Reference: Essex Trails Proposed Alignment

## **CRO Proposed Horizontal Alignment**

**FIGURE 1 ESSEX TRAILS - PROPOSED VT 289 PATH ALIGNMENT**

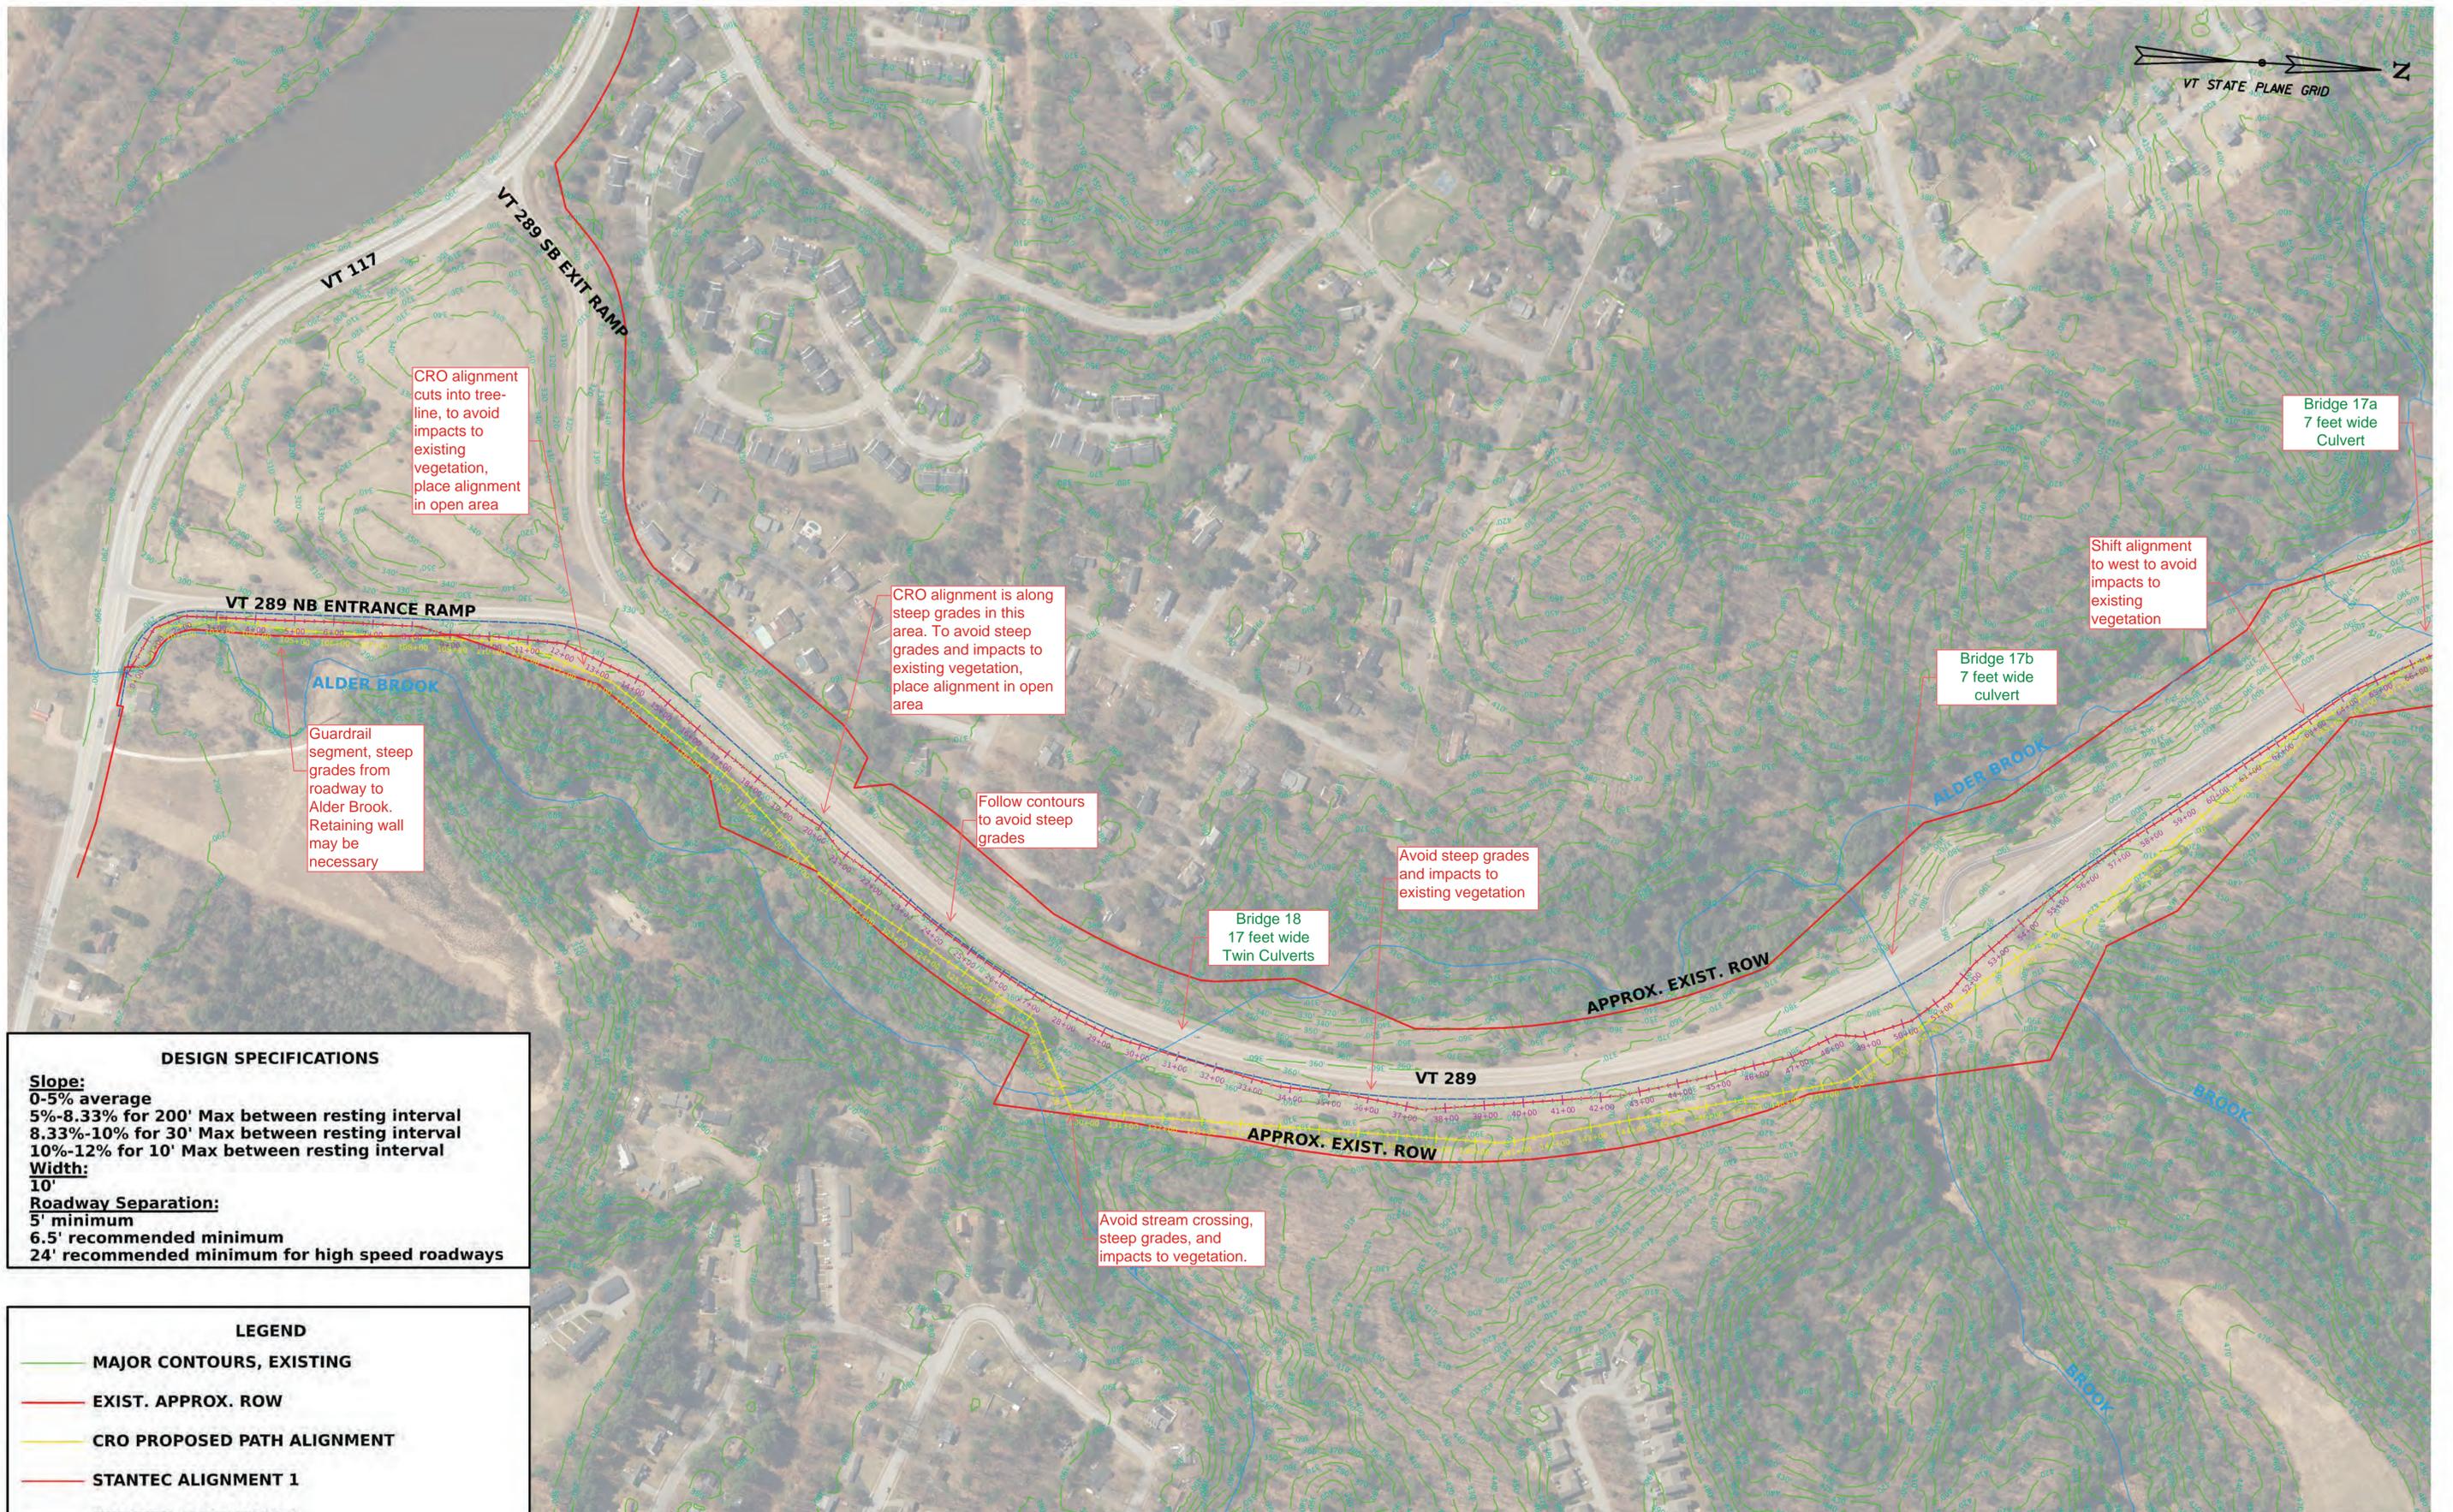
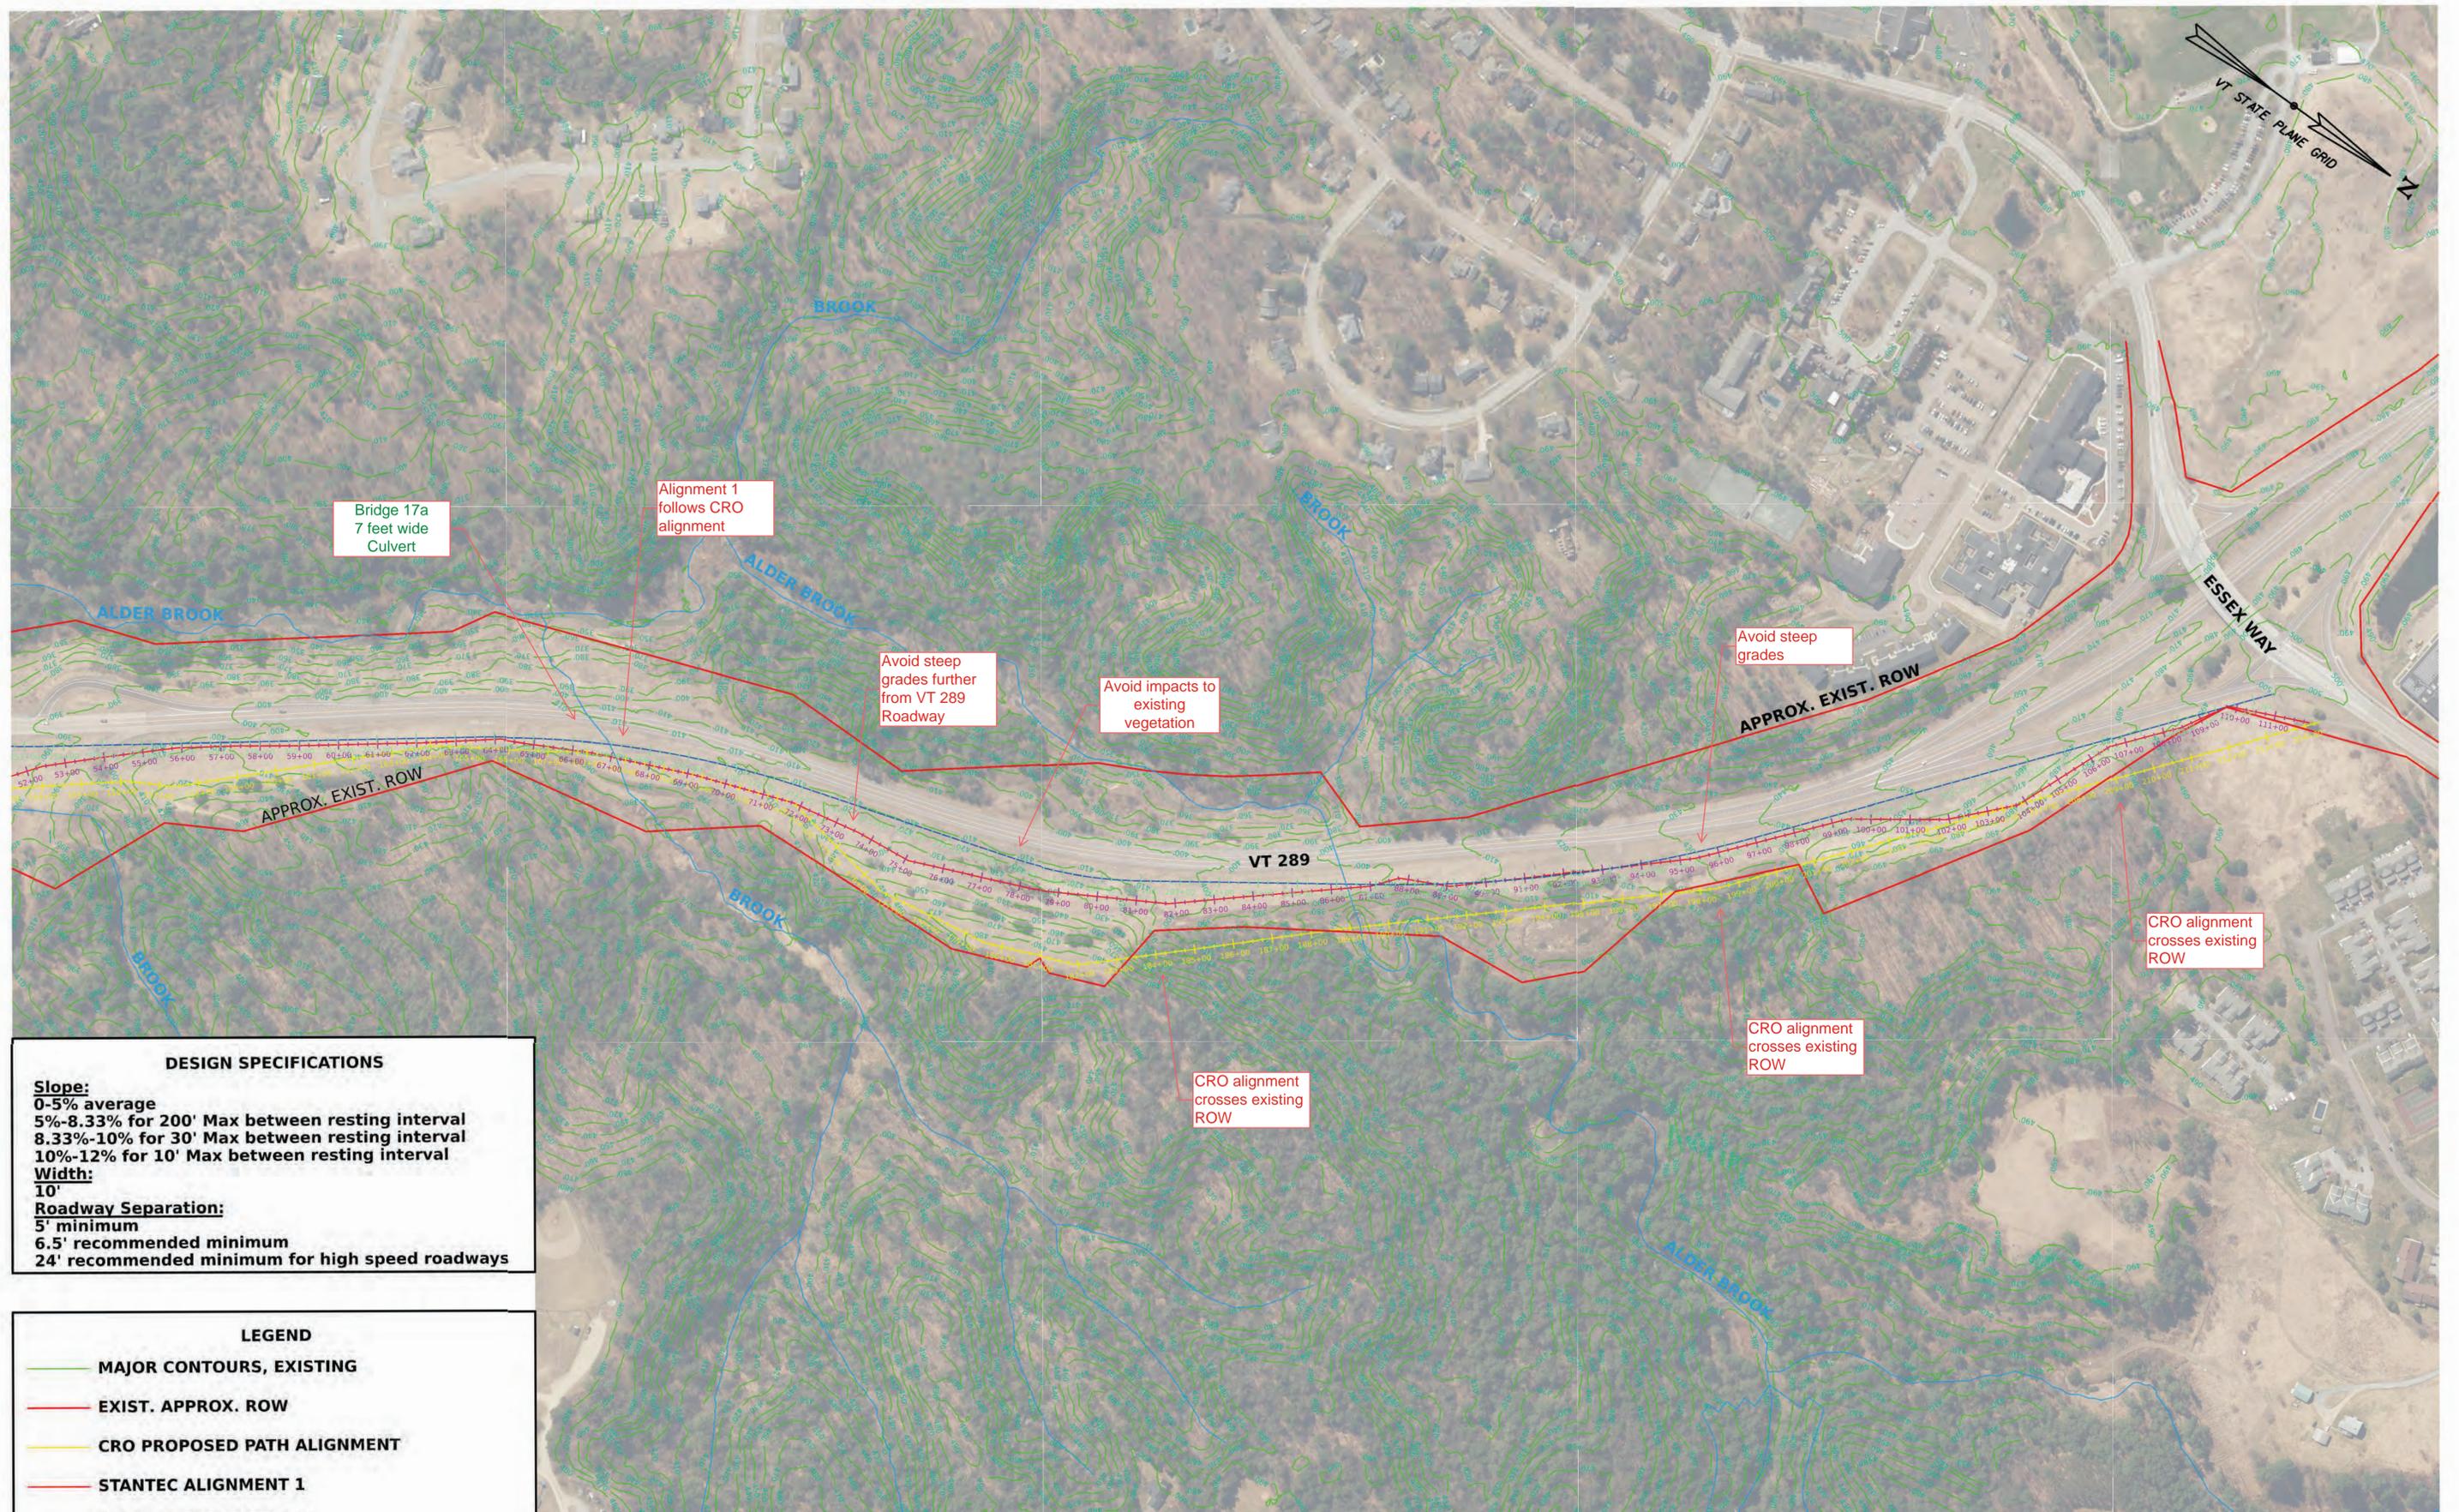
CRO's horizontal alignment and the revised horizontal alignments prepared by Stantec, along with general comments can be seen on Figure 1 (attached). The corresponding profile along existing ground can be seen in Figure 2 (attached). In general, the CRO alignment crosses steep segments, exceeding 12%, the maximum allowed by VT 289 design specifications. A majority of the grades exceed the desired average 5% grade, with some grades exceeding 20%. It crosses Alder Brook at multiple locations, which would require pedestrian/bicycle bridges. It also crosses existing state right of way (ROW) at multiple locations.

Existing Vermont state right of way limits from the Vermont Right of Way Spatial Data Hub are shown in Figure 1 (attached). The CRO path alignment crosses existing right of way at multiple locations, as labeled on Figure 1 (attached). The two proposed Stantec alignments remain inside existing approximate ROW. The planning-level cut and fill limits were determined for the two proposed Stantec alignments. Stantec compared ROW impacts by quantifying the cut and fill limits for the Stantec Alignments 1 and 2 that are outside of the existing approximate ROW. For Stantec Alignments 1 and 2, the approximate area outside of the existing ROW is 89,000 square feet and 41,000 square feet, respectively. Stantec Alignment 2 has approximately half of the ROW impacts as Stantec Alignment 1. The cost for acquiring the necessary ROW for both alignments is unknown, but acquiring more ROW is associated with higher project costs.

Stantec's revised alignments were developed to maintain grades within the design specifications for the VT 289 Corridor & Bike Path, to reduce stream crossings, and to reduce or avoid impacts to ROW, cut and fill areas, and existing vegetation. The first 600' of the alignment that runs along the VT 289 northbound entrance ramp has multiple constraints and the constructability of a path in that area requires further analysis. It is likely that a retaining wall is needed in that area as well as a pedestrian/bicycle bridge over the Alder Brook.

The first iteration of a planning-level alignment attempts to maintain the "trail" like design of CRO's alignment in the sense that it travels relatively close to the tree line without impacting it, while designing within the VT 289 Corridor & Bike Path specifications. The Stantec alignment 1, shown in Figure 1 (attached), is a series of tangents, similar to CRO's alignment. The corresponding profile can be seen in Figure 2 (attached).

The second iteration of a planning-level alignment attempts to maintain a minimum 24' offset from the edge of VT 289, as outlined in the VT 289 Corridor & Bike Path design specifications. Stantec Alignment 2, shown in Figure 1 (attached), is a series of tangents and curves. The corresponding profile can also be seen in Figure 3 (attached).
